ADDENDUM to CONTRACT DOCUMENTS

Project Name: Odessa High School
Cantwell's Bridge Middle School
Appoquinimink School District

Project Number: 17.001

Subject: **ADDENDUM 1**

ITEM #: LS-10

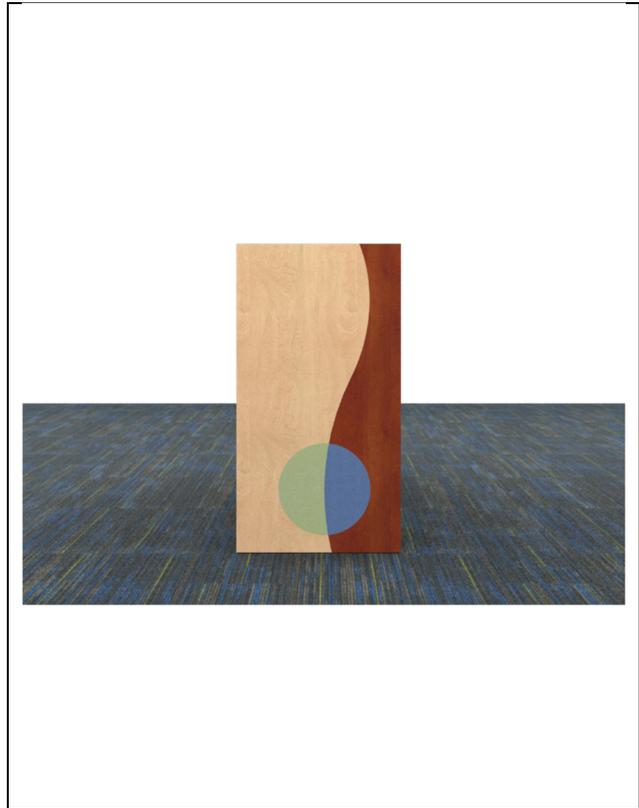
ITEM: Library Double Face End Panel – **Custom Design**

BASIS OF DESIGN: **TMC** or Approved Equal

MODEL #: Custom with wood and laminate inlays

WOOD SPECIES: Maple (**2 stain colors**)

INLAY 1: Wilsonart Sprout 4918-60 or match **TMC Toner Wood Finish – Standard Color**

INLAY 2: Wilsonart Brittany Blue D321-60 or match **TMC Toner Wood Finish – Standard Color**

Maple wood clear stain to match Liat standard panels with cherry stain inlay as shown. Two laminate inlay colors to create 14” Dia. circle at bottom of panel. **Clear Maple to match as Wilsonart Fusion 7909-60 Maple – Cherry to match Wilsonart Huntington Maple 7929-38 – Standard finishes are acceptable if colors match**

DESCRIPTION: Custom End panel shall be constructed of 1-1/4” thick particleboard core with grade “A” veneer on both faces. The exposed edges shall be externally banded with a 1/8” **solid hardwood to match clear maple finish**. End panel must be able to be attached to cantilever shelving.

ITEM #: LS-10A

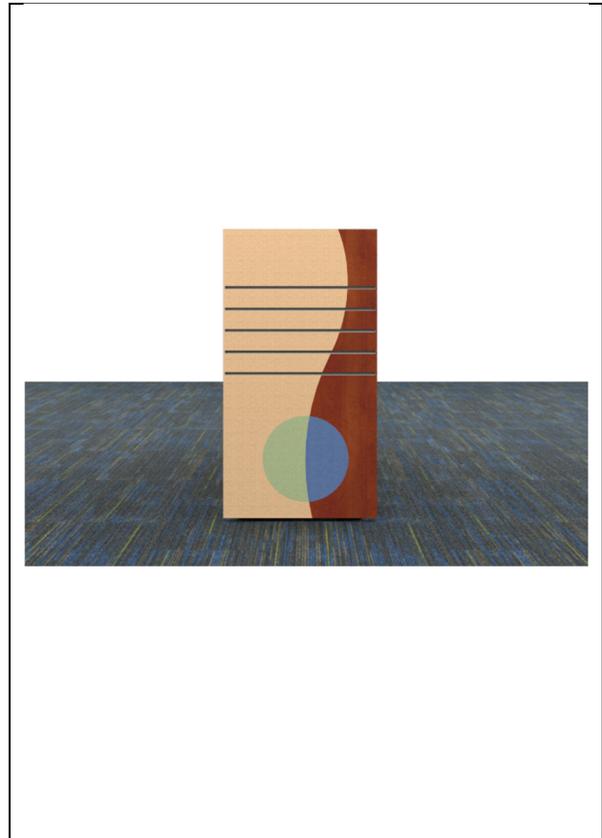
ITEM: Library Double Face End Panel with slat wall – **Custom Design**

BASIS OF DESIGN: **TMC** or Approved Equal

WOOD SPECIES: Maple (**2 stain colors**)

INLAY 1: Wilsonart Sprout 4918-60 or match **TMC Toner Wood Finish – Standard Color**

INLAY 2: Wilsonart Brittany Blue D321-60 or match **TMC Toner Wood Finish – Standard Color**

Maple wood clear stain to match Liat standard panels with cherry stain inlay as shown. Two laminate inlay colors to create 14” Dia.

circle at bottom of panel. **Clear Maple to match as Wilsonart Fusion 7909-60 Maple – Cherry to match Wilsonart Huntington Maple 7929-38 – Standard finishes are acceptable if colors match**

DESCRIPTION: Custom End panel shall be constructed of 1-1/4” thick particleboard core with grade “A” veneer on both faces. The exposed edges shall be externally banded with a 1/8” **solid hardwood to match clear maple finish. Top slat to be located 9”** from top for 5-slat panels. Slats to be routed on 3 1/2” centers and have PVC slats inserted. End panel must be able to be attached to cantilever shelving.

1 LS-10 - ELEVATION
SCALE: 1 1/2" = 1'-0"

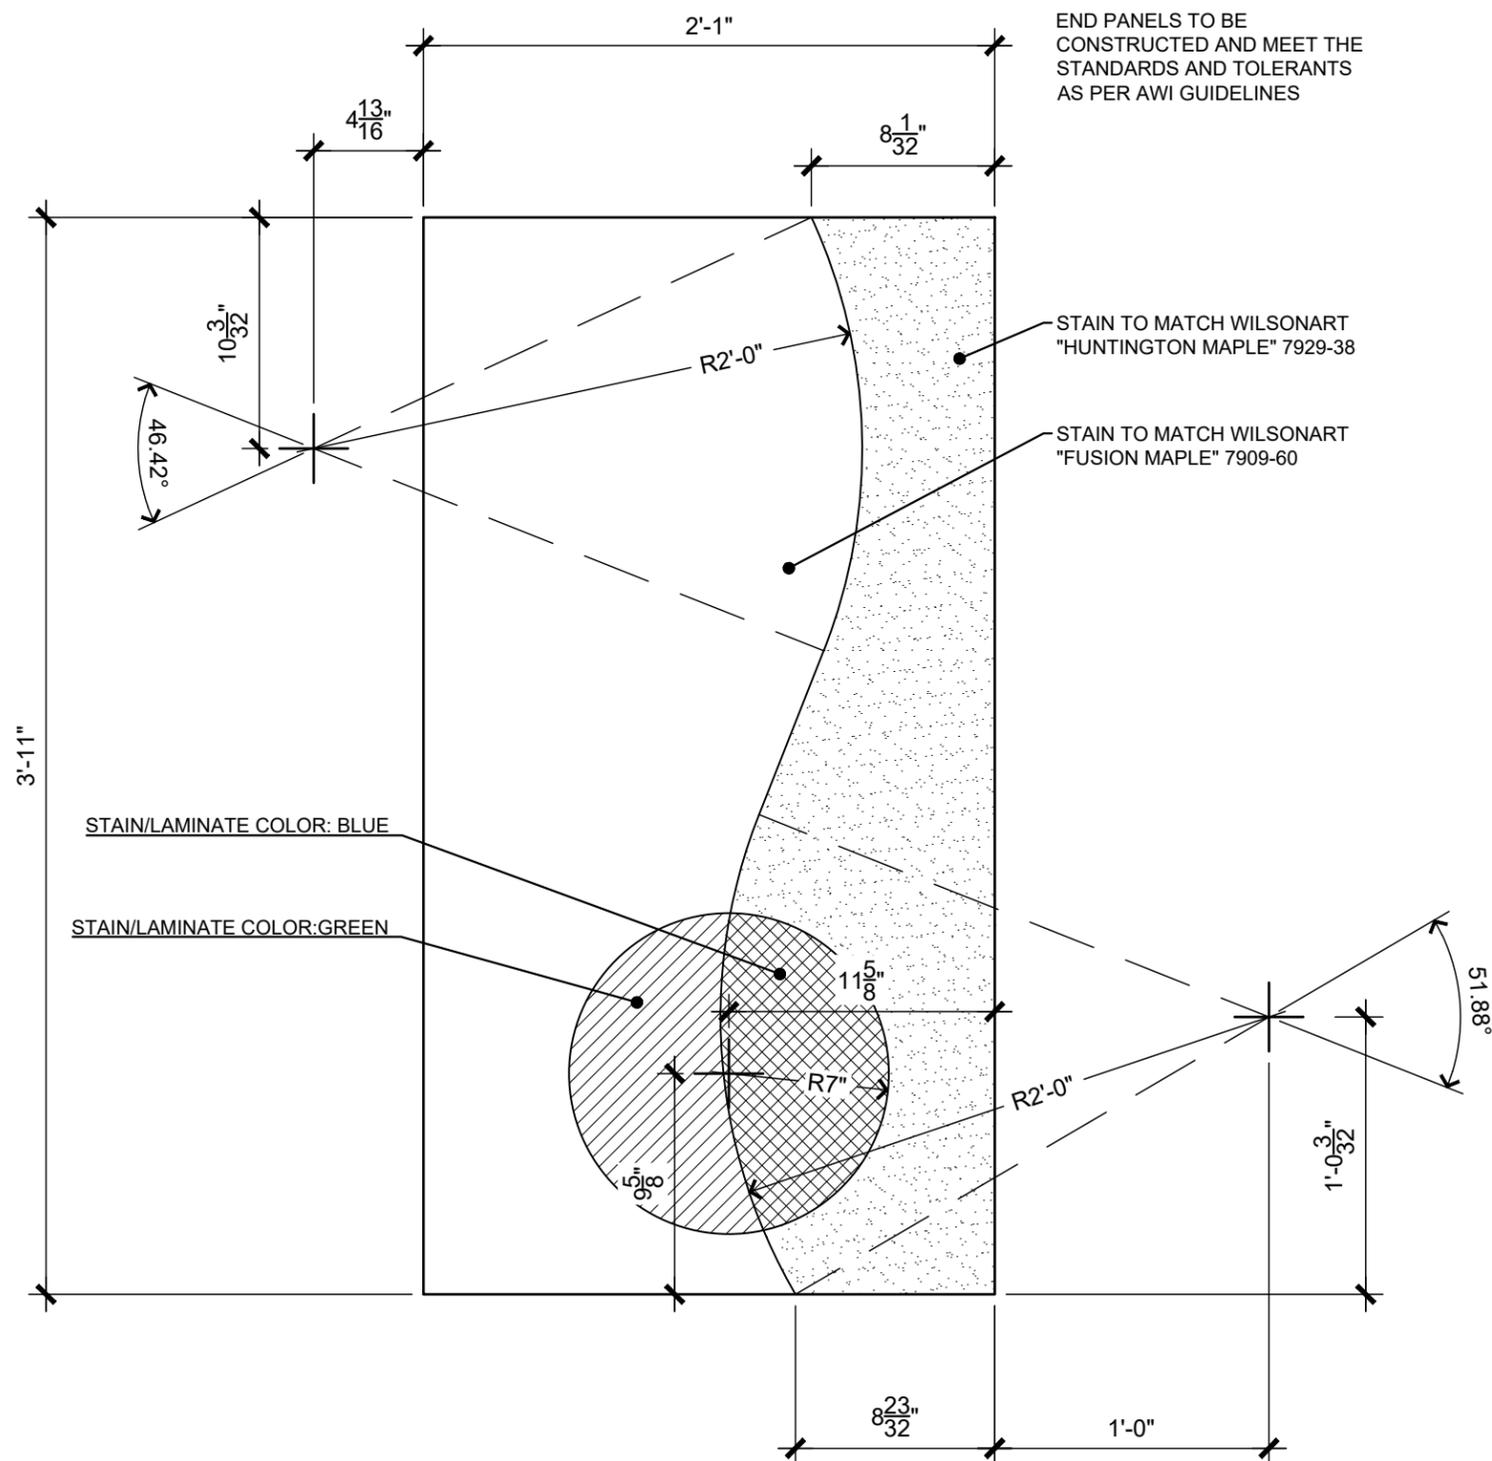
END PANELS TO BE
CONSTRUCTED AND MEET THE
STANDARDS AND TOLERANTS
AS PER AWI GUIDELINES

STAIN TO MATCH WILSONART
"HUNTINGTON MAPLE" 7929-38

STAIN TO MATCH WILSONART
"FUSION MAPLE" 7909-60

STAIN/LAMINATE COLOR: BLUE

STAIN/LAMINATE COLOR: GREEN
